# Access Compliance Report

## Public Rights-of-Way

Intersection ID: 3551	Main Street: ARDEN_GATE_LN	Cross Street: TAVERNAY_PY	Location:	E
ADA ID: E4E29B8BC28D	Ramp Type: Perp	Initial Pass/Fail: Fail	Overall Compliance: No	Severity Score: 1.25
Codes/Mitigation Info/Possible Solution		Field Measurements/Component Compliance

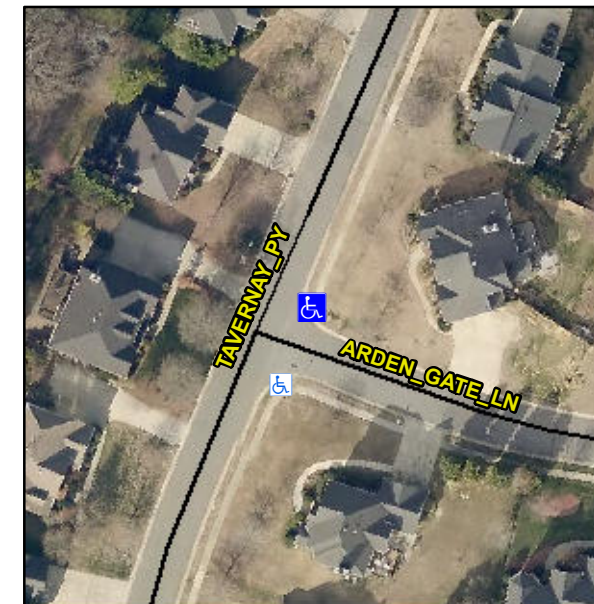
**Not Found, R304.5.3**

Compliance	Description	Data	Compliance	Description	Data
N/A	Ramp Length (in)	47.0	Yes	Ramp Slope (%)	6.6
Yes	Ramp Width (in)	48.0	No	Ramp XSlope (%)	4.5
N/A	Flare Type LT	N/A	N/A	Flare Type RT	N/A
N/A	Flare Slope LT (%)	N/A	N/A	Flare Slope RT (%)	N/A
N/A	Flare Traversable LT?	N/A	N/A	Flare Traversable RT?	N/A
N/A	Landing Length (in)	N/A	N/A	DWS Provided?	N/A
N/A	Landing Width (in)	N/A	N/A	DWS Contrast?	N/A
N/A	Landing Slope (%)	N/A	N/A	DWS Length (in)	N/A
N/A	Landing X Slope (%)	N/A	N/A	DWS Full Width?	N/A
N/A	Landing Curb? (Y/N)	N/A	N/A	DWS Offset (in)	N/A
N/A	Shared Landing?	N/A			
N/A	Gutter Ponding?	N/A	N/A	Gutter Slope (%)	N/A
N/A	Gutter Lip Ht (in)	1.0	N/A	Gutter X Slope (%)	N/A
N/A	Painted X Walk1?	No	N/A	Painted X Walk2?	N/A
	X Walk 1 Direction	To SW		X Walk 2 Direction	N/A
N/A	X Walk 1 Width (in)	N/A	N/A	X Walk 2 Width (in)	N/A
	X Walk 1 Slope (%)	3.5		X Walk 2 Slope (%)	N/A
	X Walk 1 X Slope (%)	3.1		X Walk 2 X Slope (%)	N/A

**Remove & Replace Entire Ramp.**
